10/532,166

Yuji Saai

Office Action Summary

1. Claims 1-5 are rejected under 35 U.S.C. 102(b) as being anticipated by Feesler (US 6,343,550).

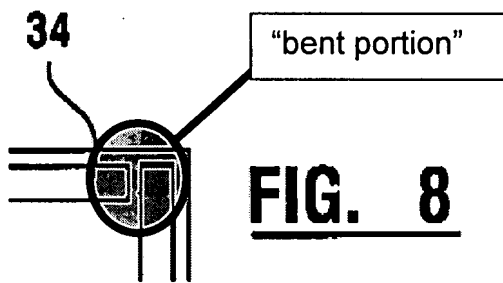
Regarding claim 3, Feesler further discloses “wherein said top surface is shaped as a line when viewed from above (figures 6-8), and has a bent portion (figure 8; see portion of image below for how Examiner interprets the term ‘bent portion’).”
